DATE: 10.15.2019
TO: ProTrak
FROM: Mitesh Baxi
Traffic Engineering

■ **OLEANDER COMMONS [TRC Plan Review #2]**

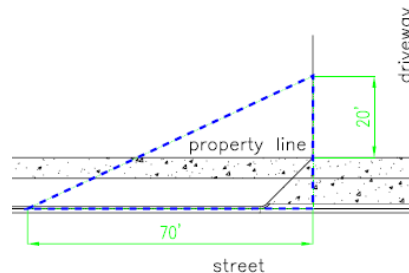
1. Wheelchair ramps shall be installed at the corner of all the street type driveways, per NCDOT and/or City standards. Connect sidewalk with ramp.
2. Stop bar and stop sign is recommended for non-signalized street type driveways. It shall be installed in advance of the potential crosswalk and outside Oleander Dr ROW.
3. For all the parking spaces where the concrete wheel stops are provided please verify that it does meet the technical standards. 15.5' clear parking length must be available after installation of the wheel stop. The minimum requirement for the vehicle overhang is 2.5' including the width of the wheel stop. [Page 7-20 of CofWTSSM]
4. Revise and apply the City's 20'x70' sight distance triangle at each driveway as per below image on the site plan and landscaping plan. [Sec.18-529(c) (3) CofW LDC] [Sec. 18-812 CofW LDC].
